Survey for Mayfair Crown Residents

LOUDOWN COUNTY FIELDS FARM ROAD PROJECT ALTERNATIVE DESIGN PROPOSAL (10/14/2022)
 SUBMITTED BY LLOYD HARVING, 845 PENCOAST DRIVE, PURCELLVILLE, VIRGINIA 20132

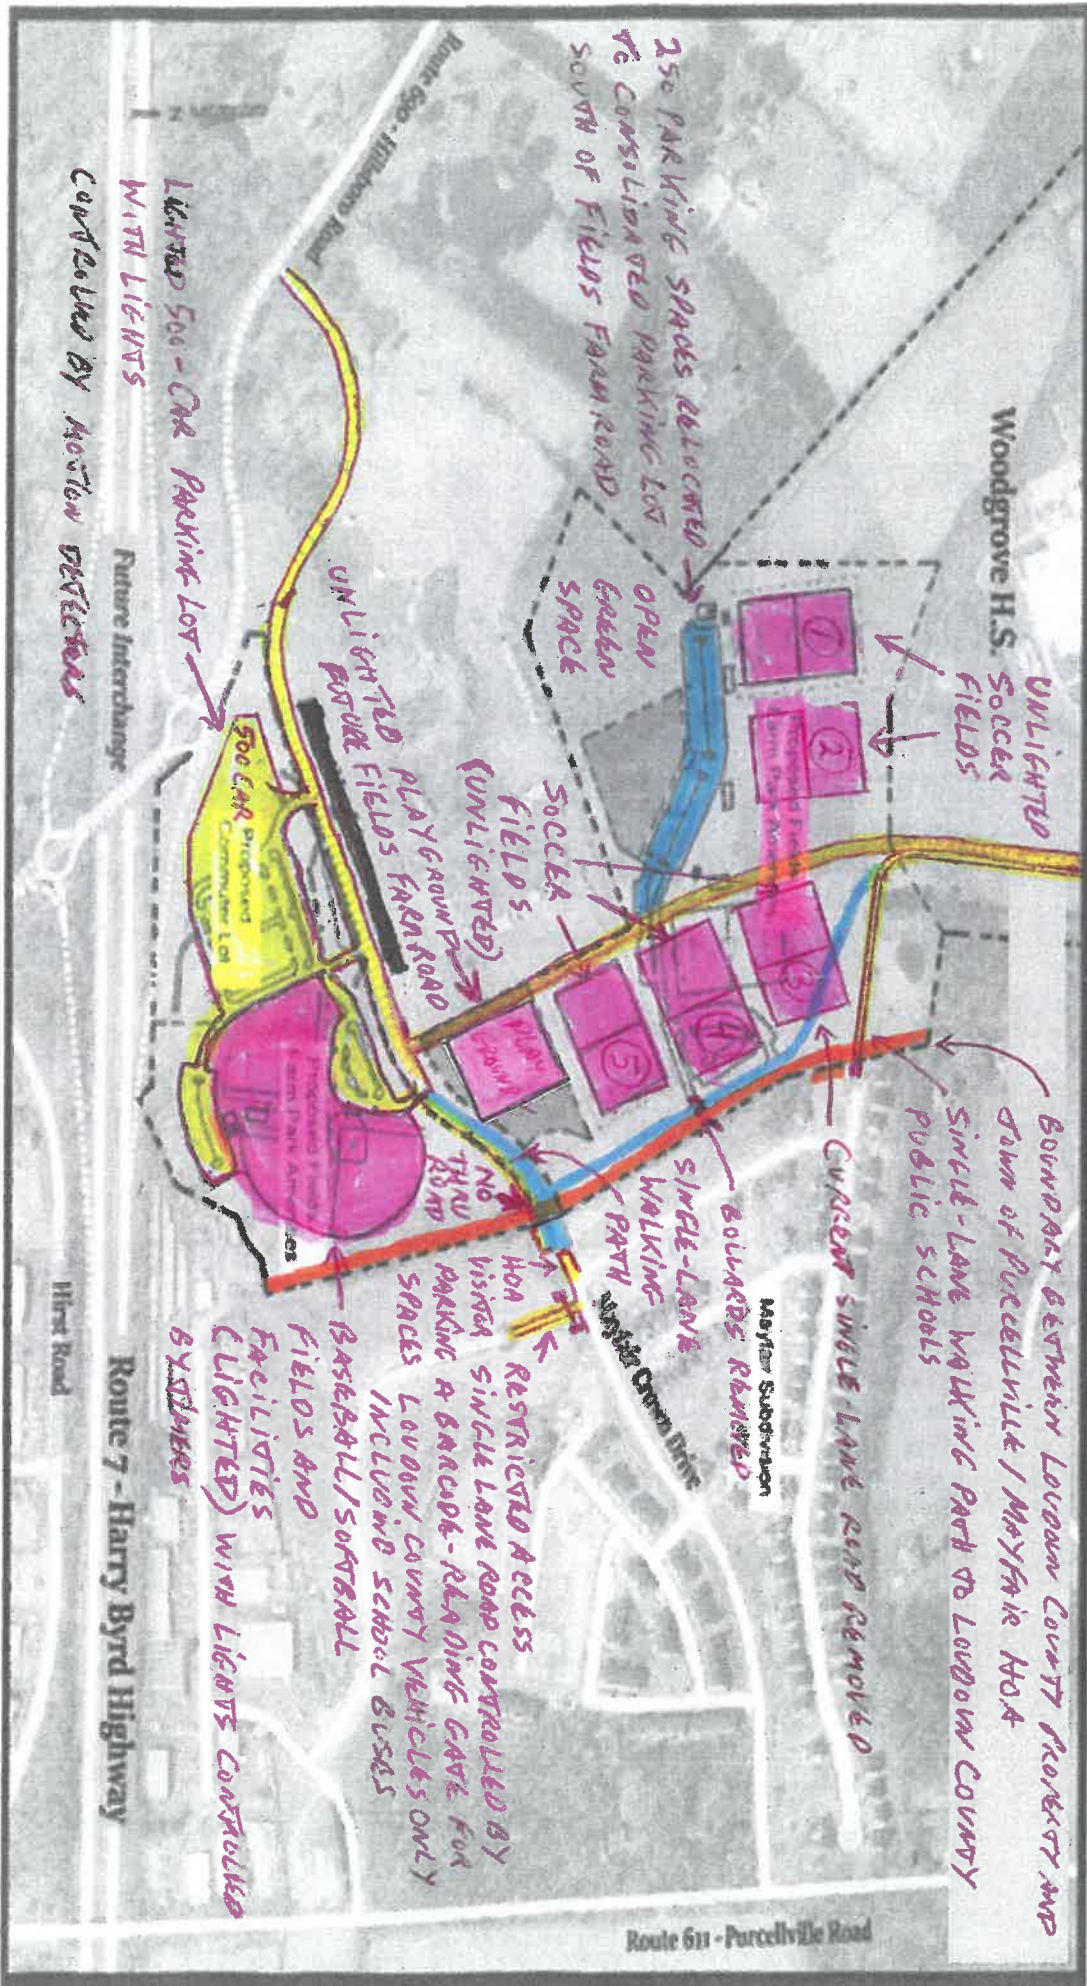
6	Do nothing—leave it as is!!	10/15/2022 12:01 PM
7	A PDF of an alternative design proposal is attached which includes the following elements: 1. Do not build a thru connection between Mayfair Crown Drive and Fields Farm Park Road. 2. Move the Loudoun County Public Schools Southern access road further to the West. 3. Build a pedestrian path from Upper Heyford Place to the Southern Public Schools access road. 4. Do not build any parking spaces near the soccer fields and relocate those 250 parking spaces to the joint commuter/ athletic fields parking lot South of Fields Farm Park road. 5. Build a pedestrian path from Mayfair Crown Drive to Fields Farm Park road. 6. Do not install outside lighting for the soccer fields. 7. Install outside lighting for the baseball/softball fields controlled by timers. 8. Install outside lighting for the joint commuter/athletic fields parking lot activated by motion detectors. 9. Build a playground or picnic area North of the baseball/softball fields. 10. Build five (5) soccer fields, with two (2) to the West of the Public Schools Southern access road and three (3) to the East of the Southern access road. 11. Build two (2) baseball and one (1) softball fields. 12.	10/14/2022 9:20 PM

YELLOW = NEW ROADS/STREETS/WALKING PATHS AND PARKING LOTS TO BE BUILT BY LOUDOWN COUNTY OR PURCELLVILLE
 PINK = NEW STRUCTURES TO BE BUILT BY LOUDOWN COUNTY
 BLUE = STRUCTURES THAT WILL NOT BE BUILT BY LOUDOWN COUNTY OR TOWN OF PURCELLVILLE
 ORANGE = VEGETATION/TREES TO BE REMOVED BY LOUDOWN COUNTY
 ↓ TO FIELDS FARM ROAD
